From: Neil Atherton
Sent: 3 Oct 2019 21:52:50 +1000
To: Contact Us
Subject: DA0407/2019
Attachments: Photo kitchen.jpg, Photo living room.jpg, Photo 3 sun.jpg

We write to express our concerns / objections to the proposed development at 11B-11D Churchill Crescent, Newstead (DA 0407/2019).

From: Lisa Davis
Sent: 14 Oct 2019 13:15:17 +1100
To: Contact Us
Cc:
Subject: Development Application 11b-11d Churchill crescent Newstead

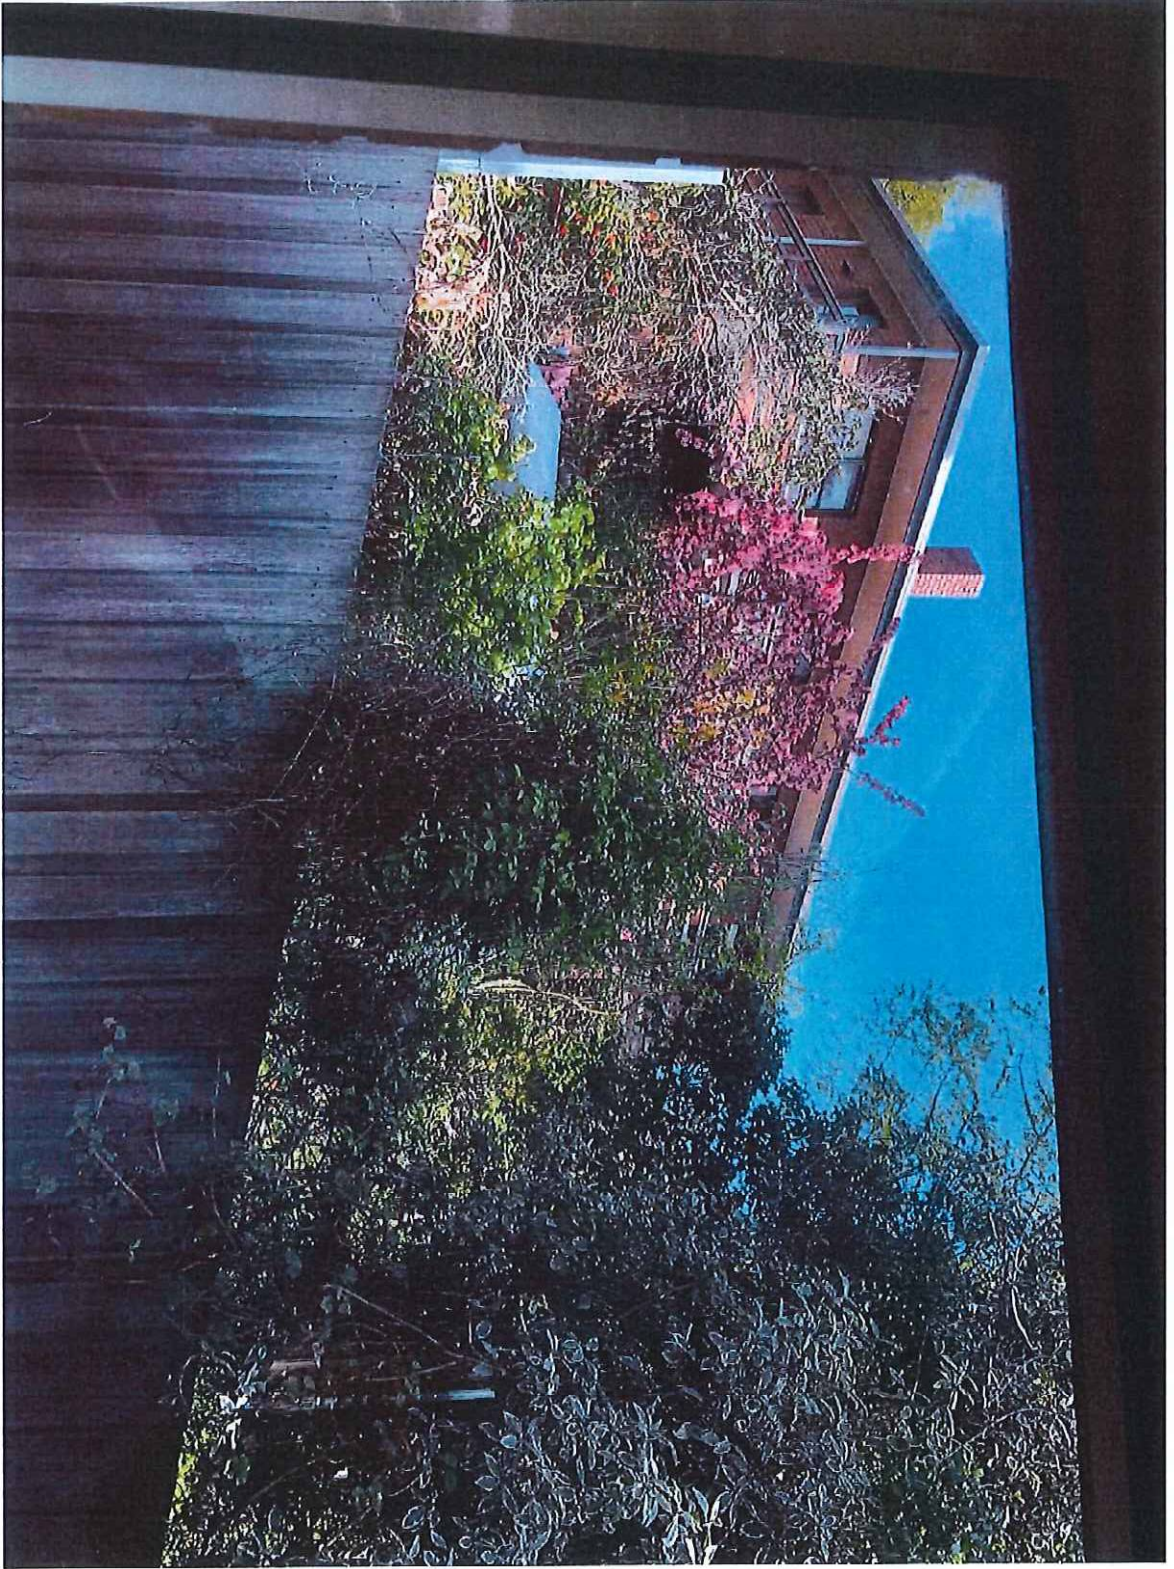
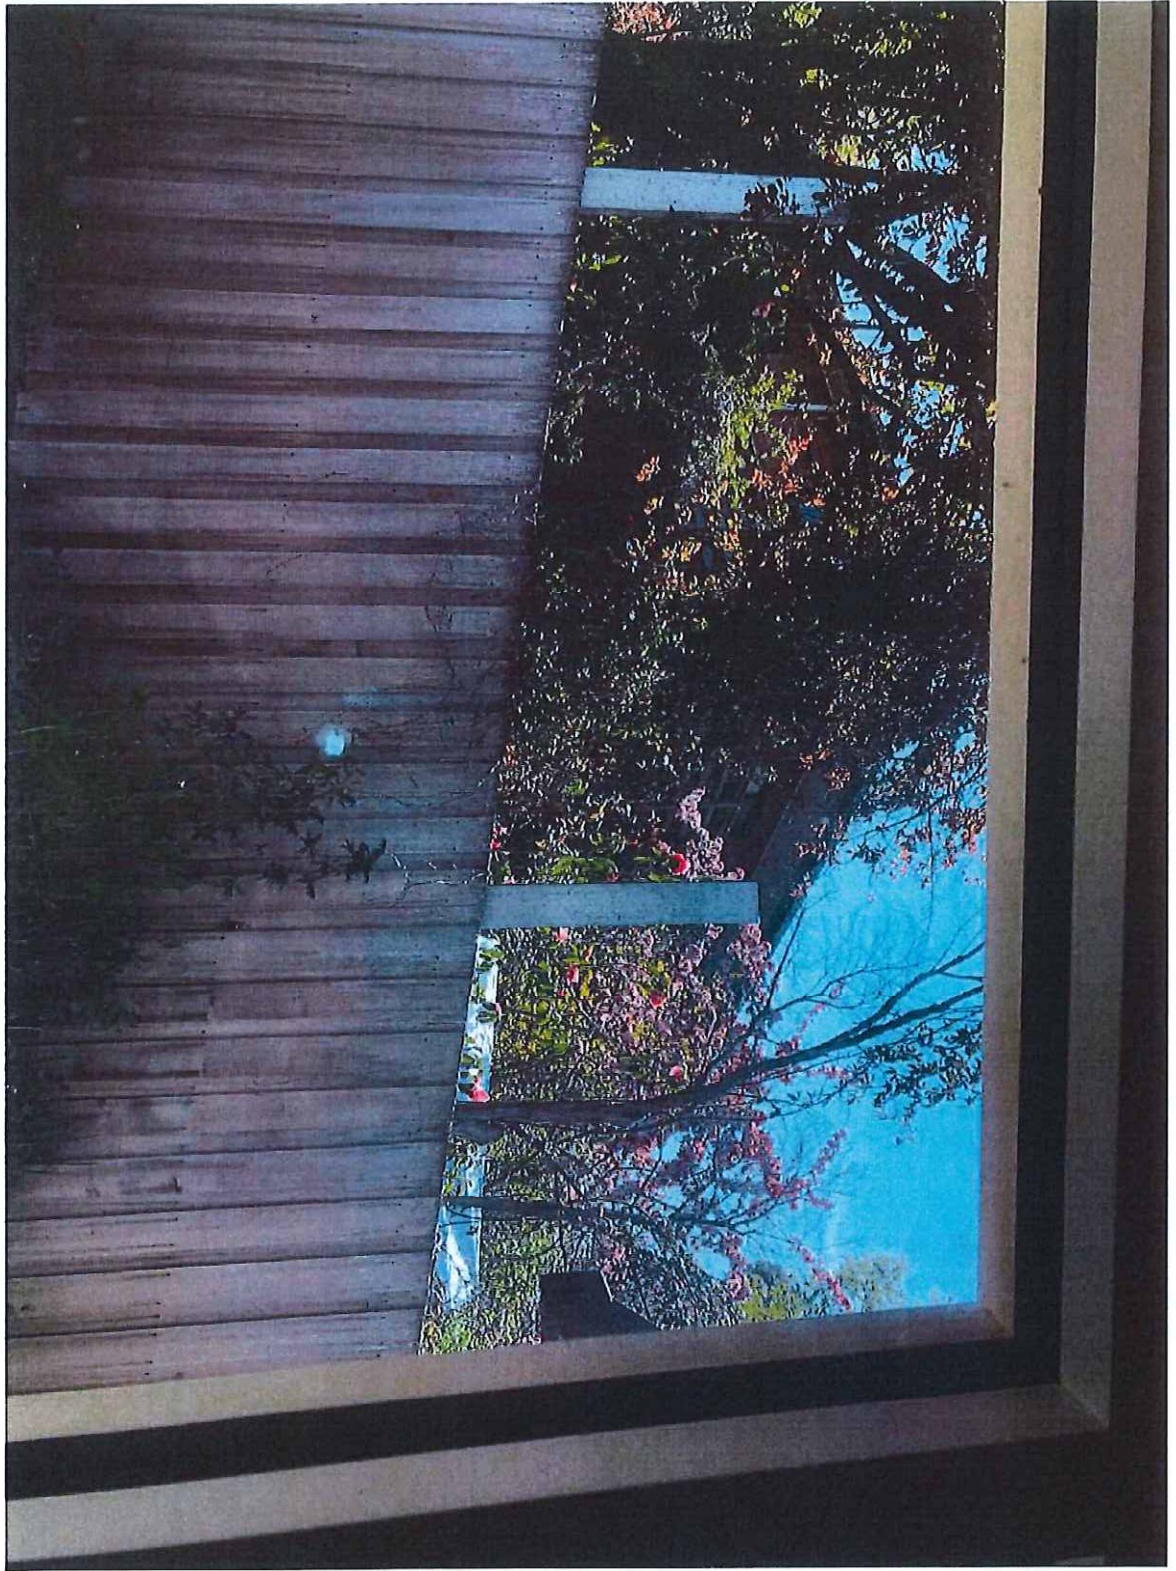
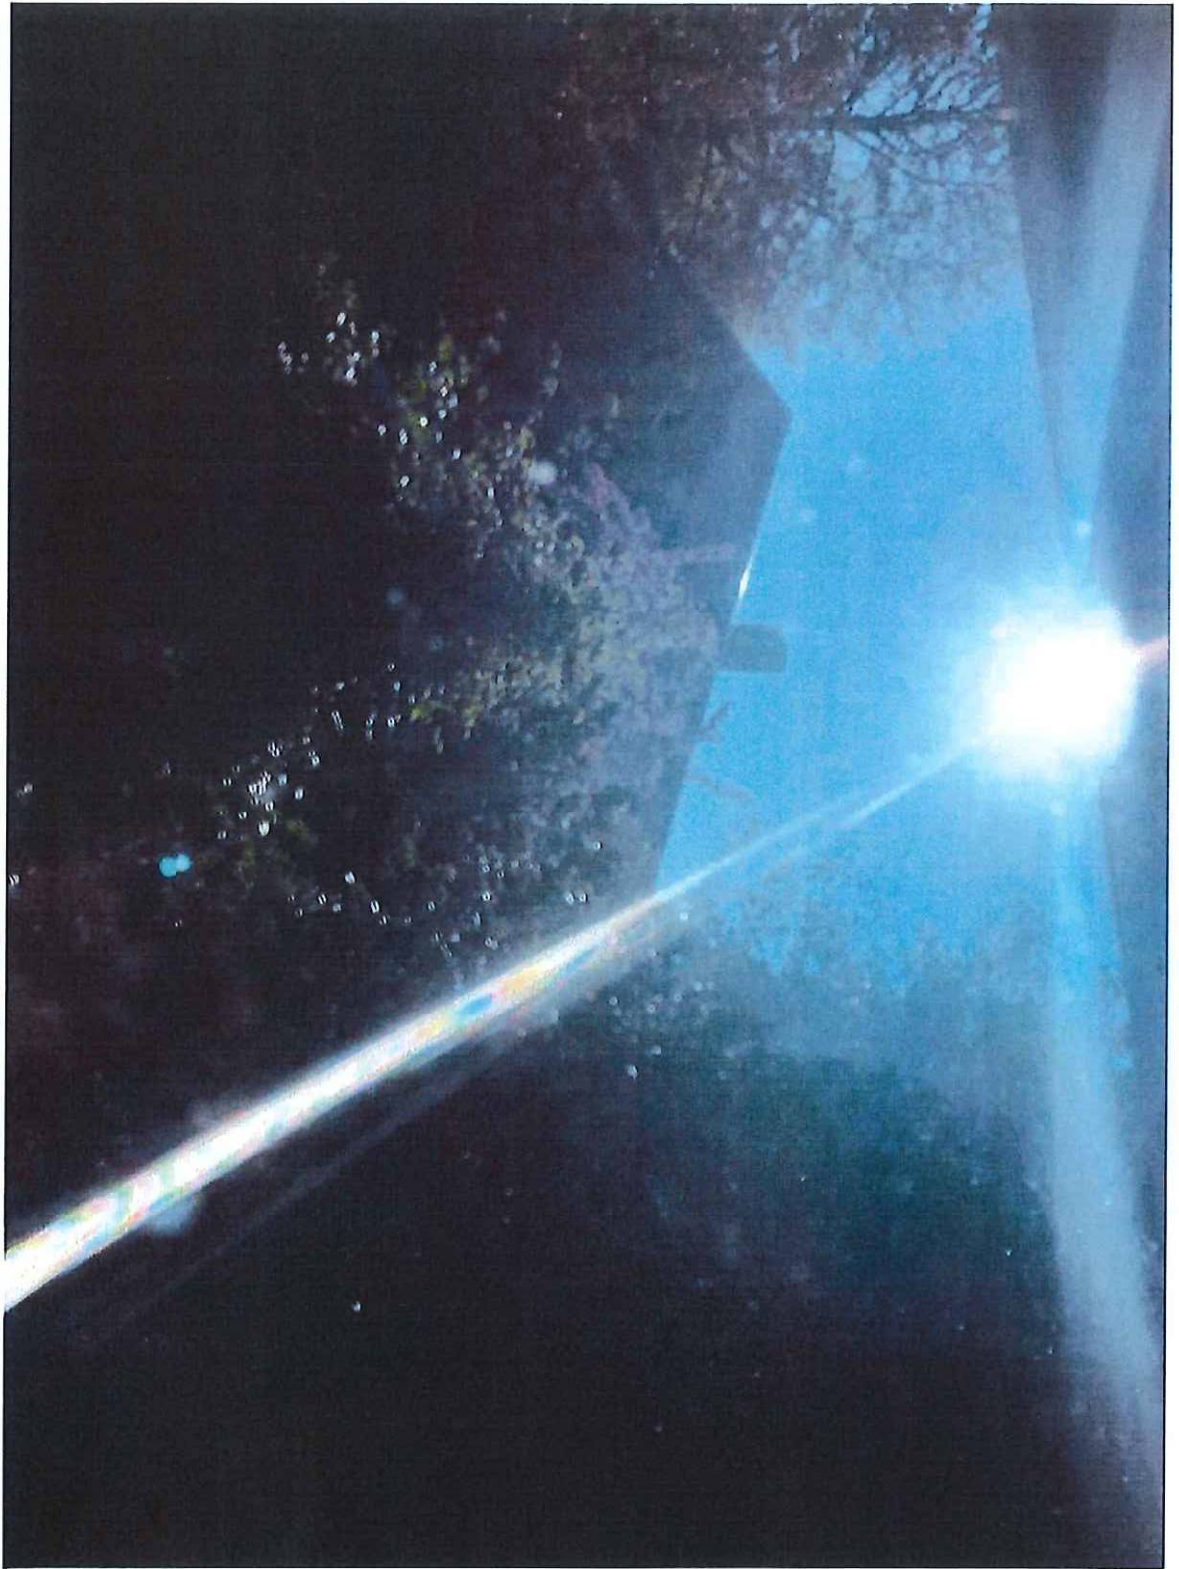
We are concerned regarding the proposed height of the alterations and additions to the existing dwelling.

As stated in the DA the natural slope of the land is significant and falls to the south and east. The existing dwelling currently overlooks our property including two living areas namely kitchen/dining room and living room. (Photos attached). The proposed advancement of the footprint of the building to the southeast and the addition of a second storey will further impact on our privacy. In addition, it is likely to impact on the amount of sunlight we receive in winter. No shade assessment has been included in the planning application. Attached is a photo taken at 14:52, 2nd Oct from our kitchen/dining room. It shows the position of the afternoon sun in relation to the current property before the addition of any extension. What also needs to be considered is what would the sun position be in winter? The proposed development protrudes above the 8.5m planning envelope by 1.8m - adding significant height for no apparent structural reason.
